Addendum No. 2
Wound Care Relocation
Kings Daughter's Medical Center
Russell, Kentucky

Addendum Issue Date: November 12, 2025

This Addendum is a modification of the Project Manual and Drawings dated September 9, 2025 for the construction of the above listed project. The modifications, revisions, and clarifications are as follows:

Issued by: Zachwieja Workman Architects/Consultants, Inc.

DRAWING
P2.3

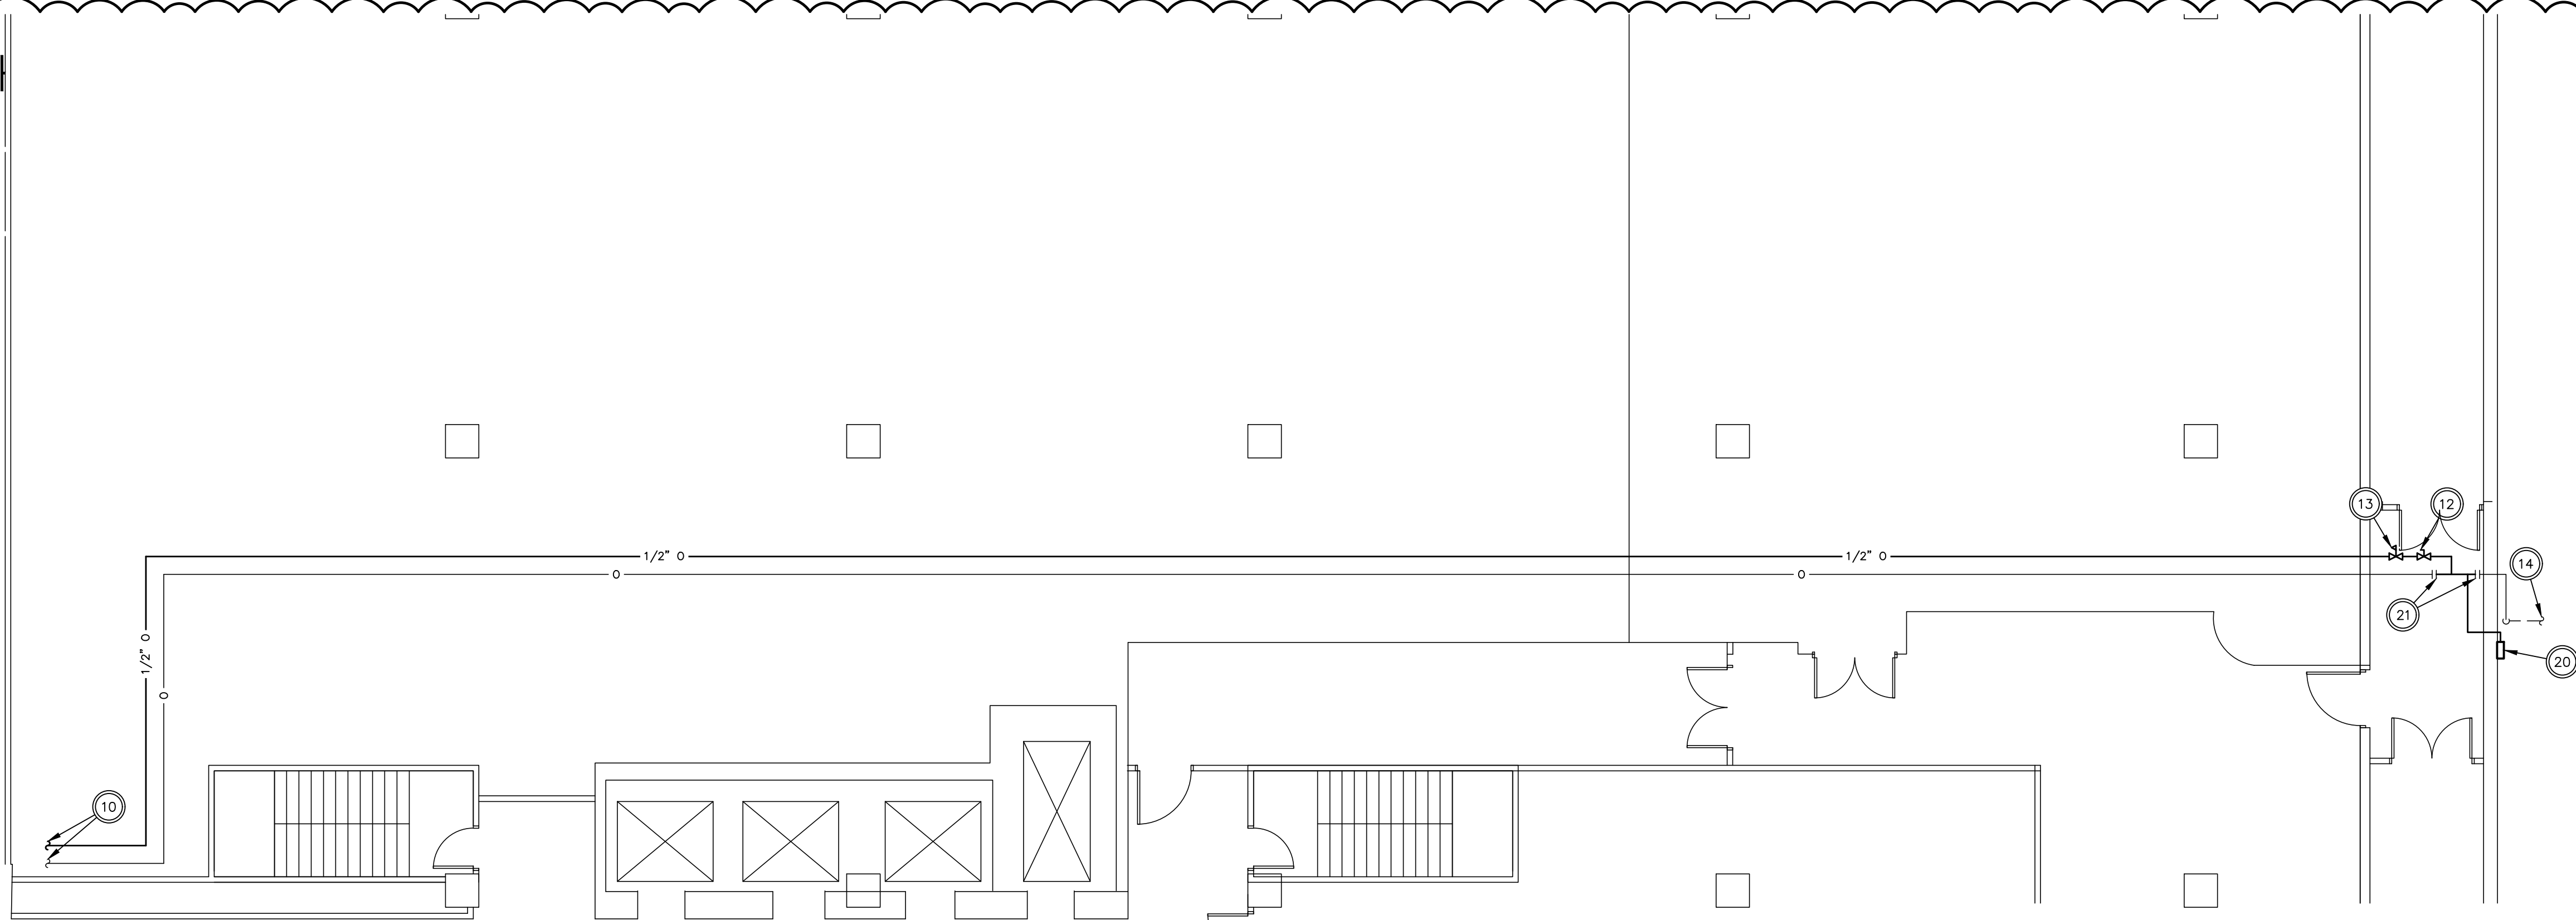
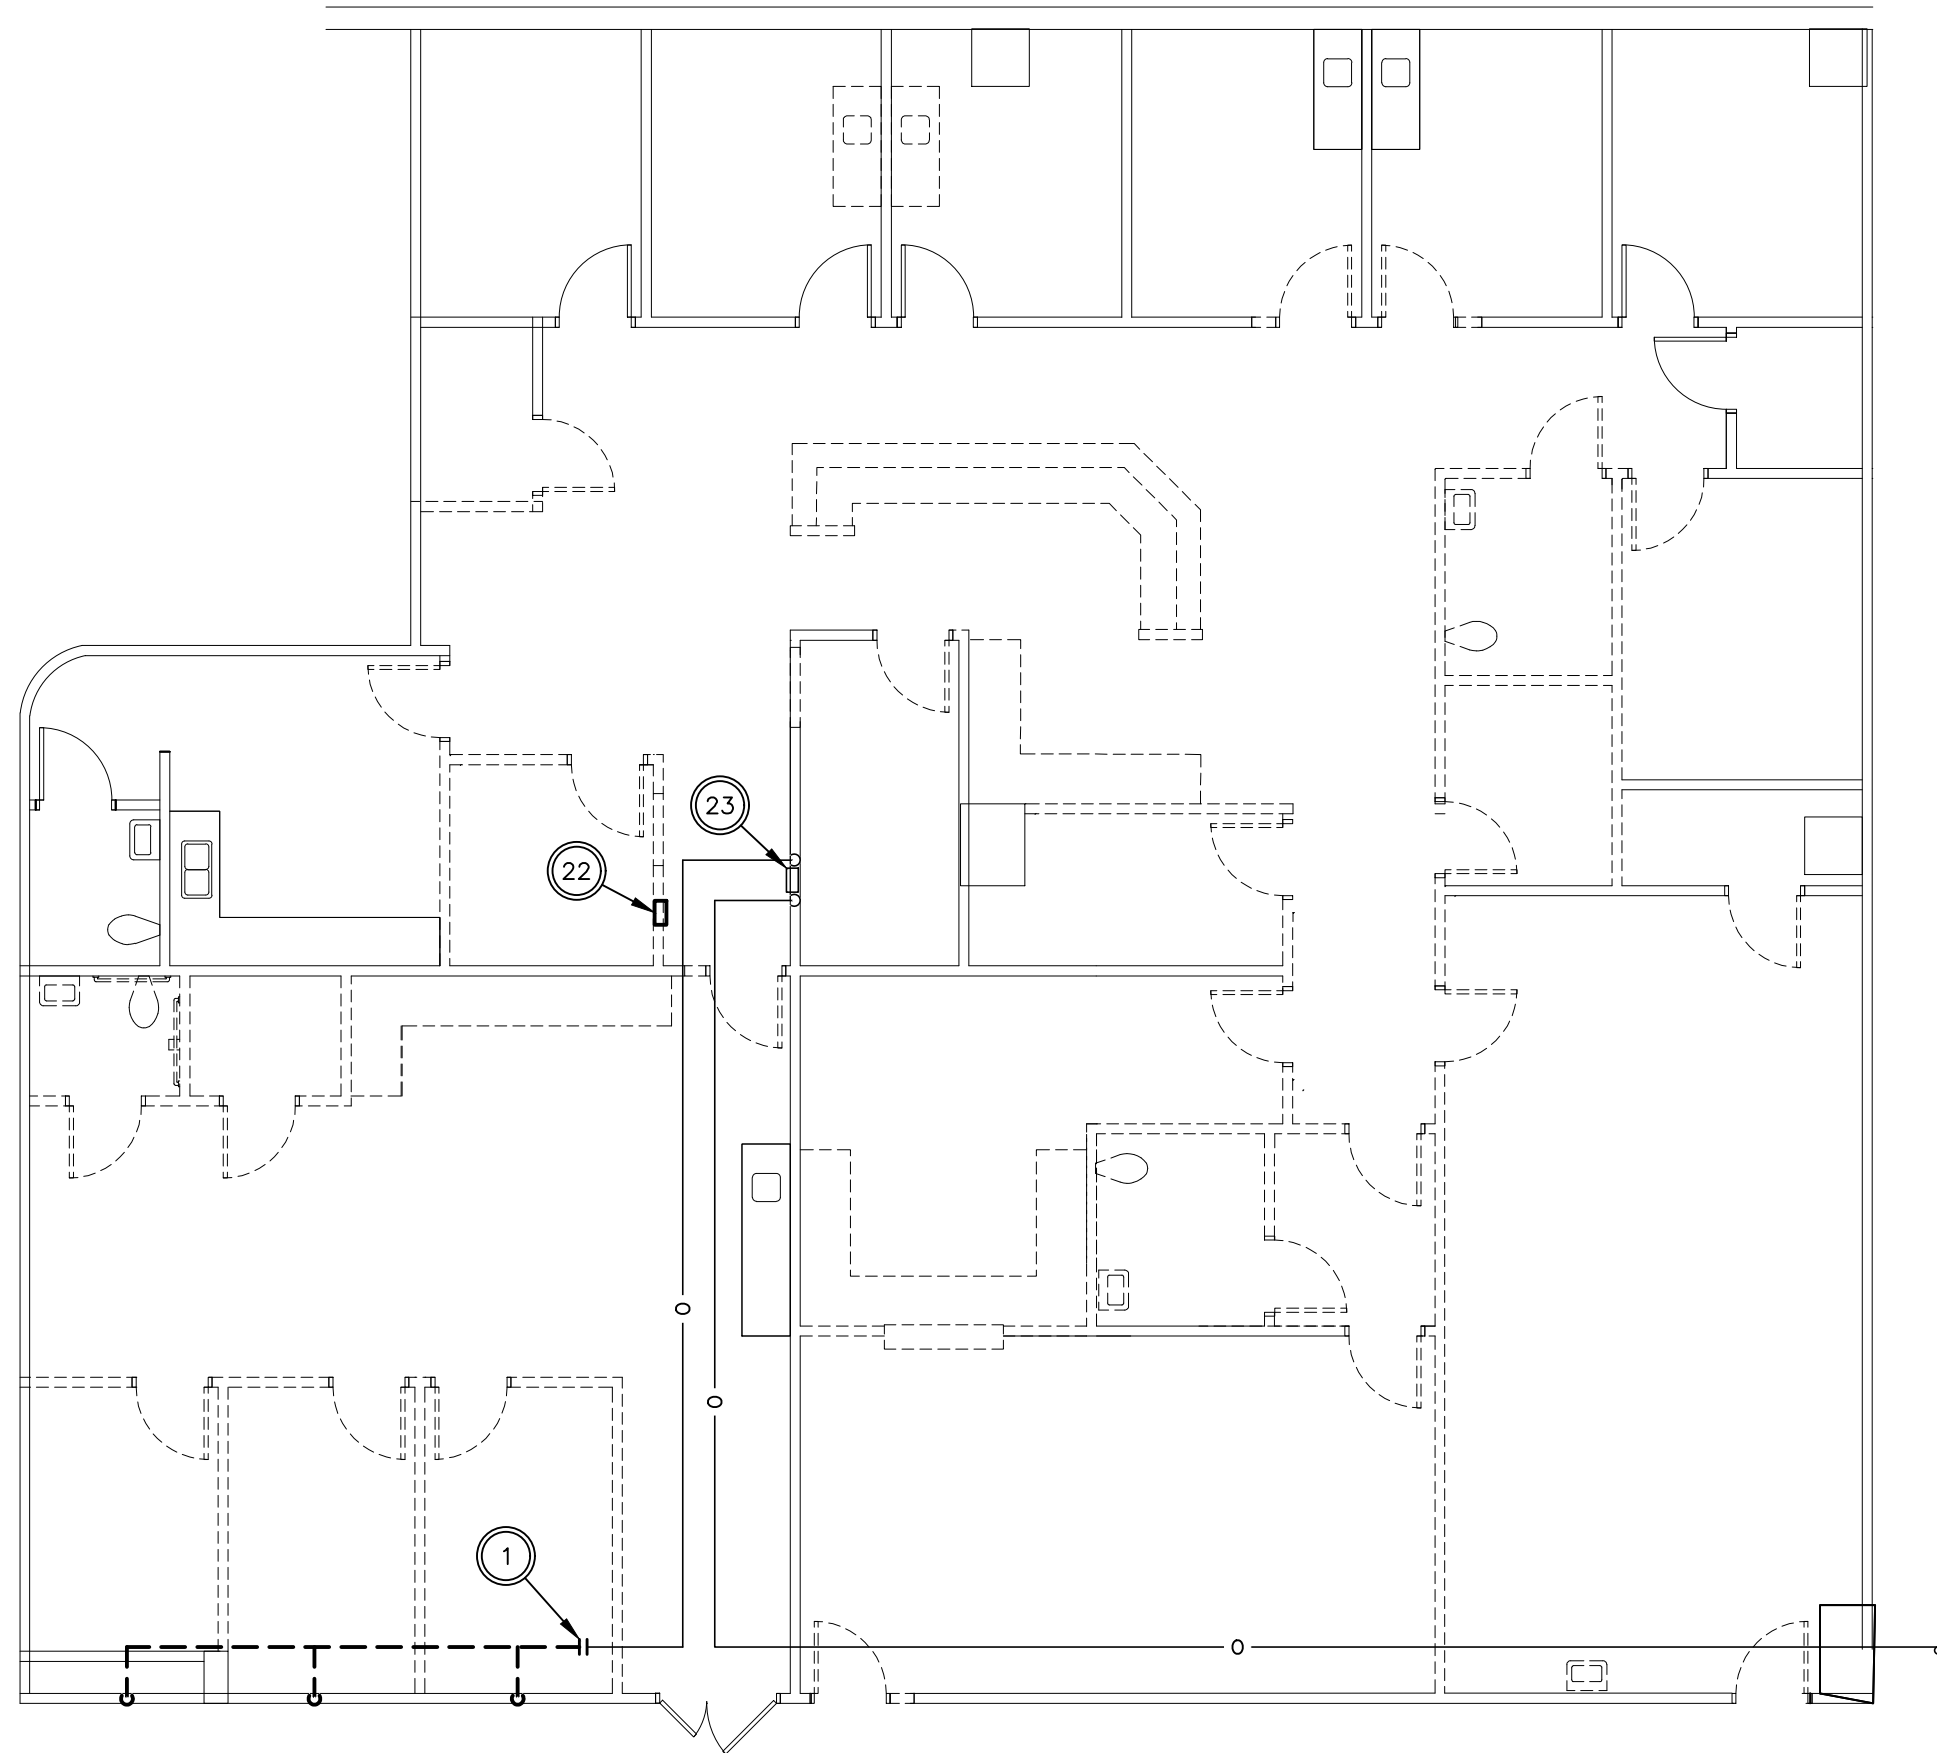
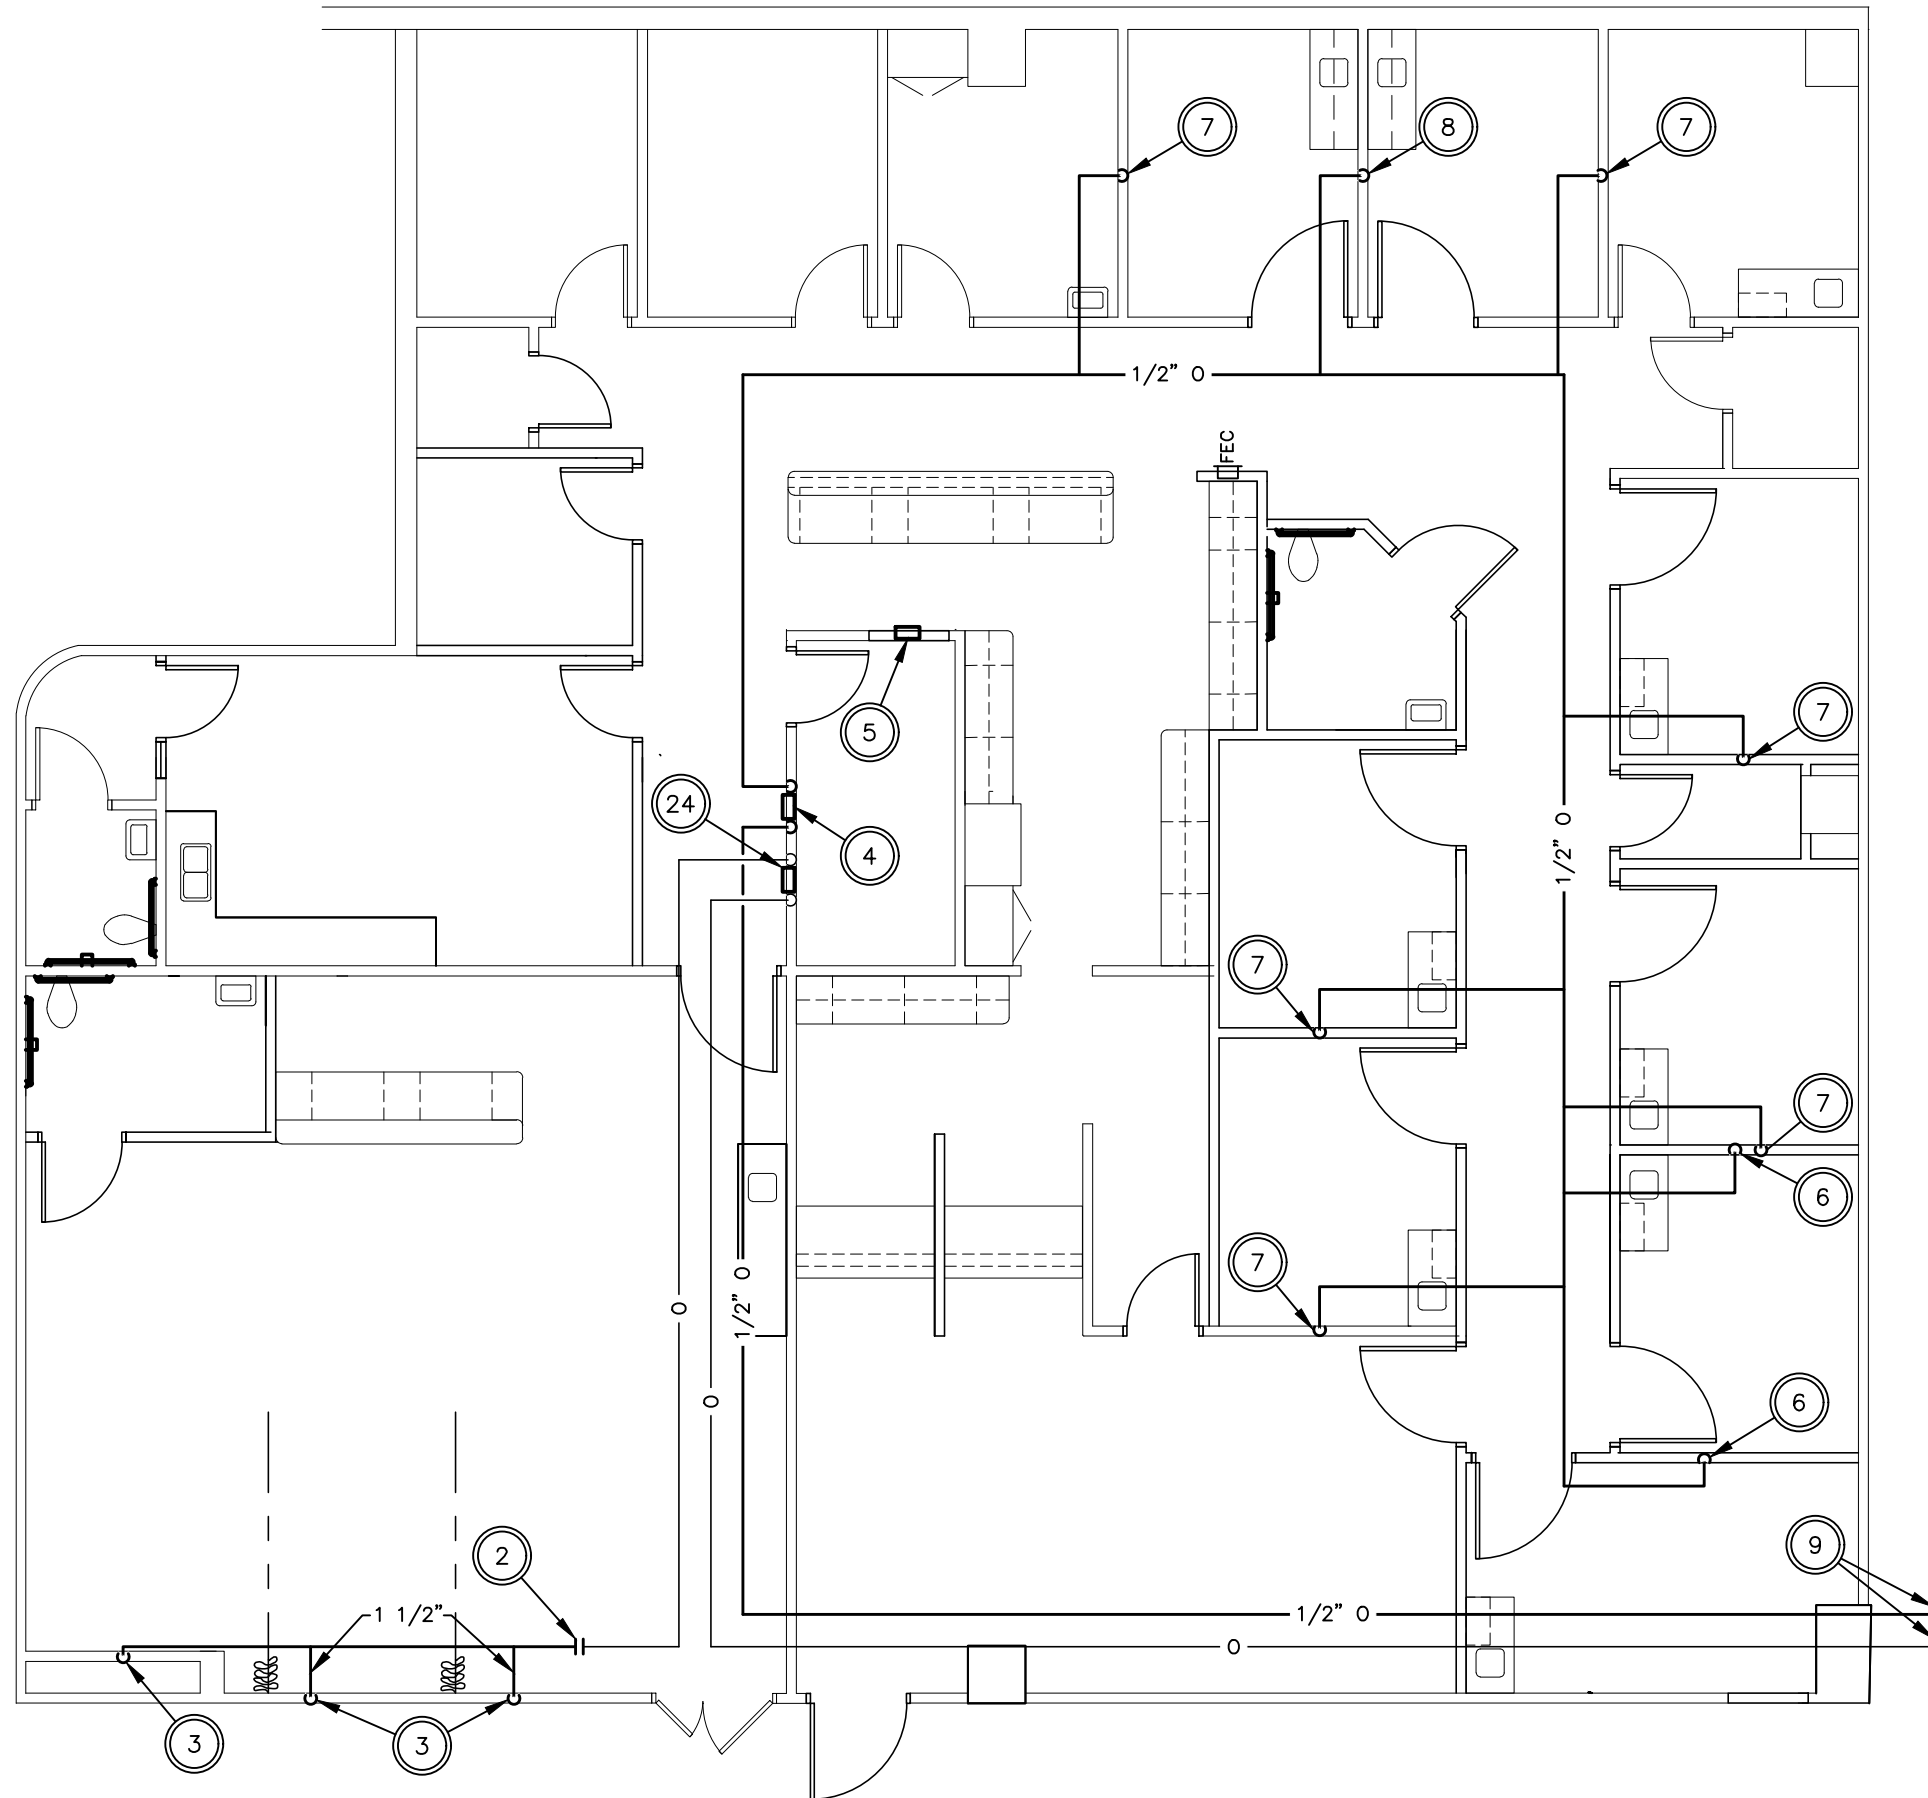
- Item 7: Drawing P2.3:
A. See attached drawing for addition of oxygen piping serving hyperbaric chambers and bulk oxygen storage system.
- Item 8: Drawing P3.1:

- 1/2" 0 PIPING DOWN IN WALL TO MED GAS OUTLET.
- 1/2" 0 PIPING DOWN IN WALL TO MED GAS OUTLET, TO BE INSTALLED UNDER ADD ALTERNATE.
- 1/2" 0 PIPING DOWN IN WALL, EXTEND 1/2" 0 PIPING TO EACH MED GAS OUTLET, TO BE INSTALLED UNDER ADD ALTERNATE.

- SEE "NEW WORK - EXPANDED FLOOR PLAN - PLUMBING" THIS SHEET FOR CONTINUATION.
- SEE "NEW WORK - FLOOR PLAN - PLUMBING" THIS SHEET FOR CONTINUATION.
- EXISTING ELECTRICAL SPLICE BOX. SPLICE AND EXTEND EXISTING CONDUIT AND WIRE TO NEW BULK OXYGEN STORAGE SYSTEM AS REQUIRED.

- LOCKABLE MED GAS SHUTOFF VALVE.
- MEDICAL GAS GRADE REGULATOR, SET FOR 55 PSI.
- EXISTING 0 LINE TO BULK OXYGEN STORAGE PAD, SEE "NEW WORK - SITE PLAN - PLUMBING" THIS SHEET FOR CONTINUATION.

- EXISTING CONCRETE PAD AND FENCED IN ENCLOSURE.
- SEE "NEW WORK - EXPANDED FLOOR PLAN - PLUMBING" THIS SHEET FOR CONTINUATION.
- 2" 0 PIPING. TIE INTO EXISTING 2" 0 PIPING IN VERTICAL.
